Work Order ID 138051

Item ID: D3394-041 Accept *N900040100* Setup Start *NS1*
Revision ID: Stop *NS2*
Item Name: Lug
Start Date: 10/21/2015 Start Qty: 20.00 *20* Cust Item ID:
Required Date: 10/21/2015 Req'd Qty: 20.00 *20* Customer:
Reference:

B	ADDED -045, SHT 4 ADDED FILLETS IN SECTION A-A. SEE PAR 152	AJS	09.04.02
A	NEW ISSUE	PH	05.02.14
REV.	DESCRIPTION	BY	DATE
DESIGN	PH	DART AEROSPACE LTD HAWKESBURY, ONTARIO, CANADA	
DRAWN	AJS		
CHECKED		DRAWING NO.	REV. B
MFG. APPR.		D3394	SHEET 1 OF 4
APPROVED		TITLE	SCALE
DE APPR.		LUG	NTS
DATE	09.04.02	COPYRIGHT © 2005 BY DART AEROSPACE LTD THIS DOCUMENT IS PRIVATE AND CONFIDENTIAL AND IS SUPPLIED ON THE EXPRESS UNDERSTANDING THAT IT IS NOT TO BE USED FOR ANY PURPOSE OR COPIED OR COMMUNICATED TO ANY OTHER PERSON WITHOUT WRITTEN PERMISSION FROM DART AEROSPACE LTD

DRAWING NO. D3394	TITLE LUG	REV. B	DART AEROSPACE LTD ENGINEERING ORDER		D.E.O. NO. D3394-B-1	SHEET NO. SHEET 1 OF 1	SCALE NTS
DRAWN AJS	CHECKED	MFG. APPR.	APPROVED		DE APPR.		
DATE 09.11.04	DATE 09.11.04	DATE 09.11.04	DATE 09.11.04		DATE 09.11.04

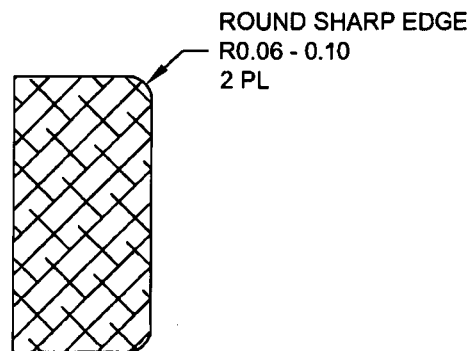
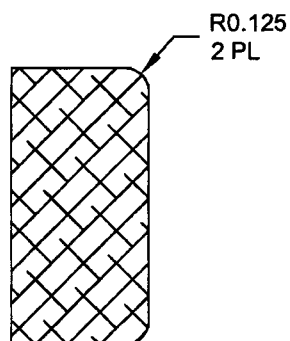
SHEET 4 ZONE A,1 MODIFY SECTION A-A AS SHOWN:

REASON: DRAFTING ERROR

DRAWING NO. D3394	TITLE LUG	REV. B	DART AEROSPACE USA, INC ENGINEERING ORDER		D.E.O. NO. D3394-B-2	SHEET NO. SHEET 1 OF 1	SCALE NTS
DRAWN JP	CHECKED SC	MFG. APPR. M	APPROVED JP		DE APPR. H		
DATE 11.05.02	DATE 11.05.09	DATE 11.05.09	DATE 11.05.09		DATE 11.05.09

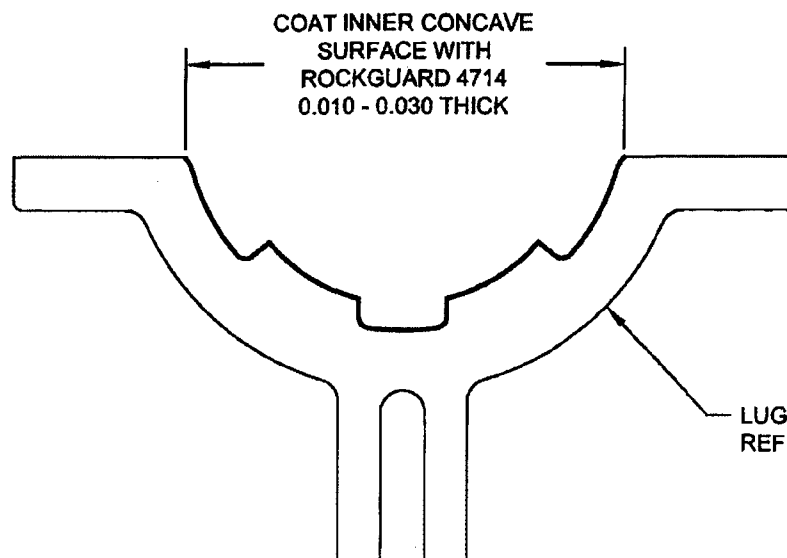
ADD D3394-xRG OPTION

D3394-xRG MOUNTING LUGS ARE INDENTICAL TO D3394-x MOUNTING LUGS, HOWEVER AFTER FINISH, COAT INNER CONCAVE SURFACE WITH "PLUS ONE ROCKGUARD 4714" AS SHOWN BELOW.

D3394-1RG LUG (SHOWN)
D3394-3RG/-5RG LUGS (SIMILAR)
D3394-041RG/-043RG/-045RG LUG ASSEMBLIES (SIMILAR)
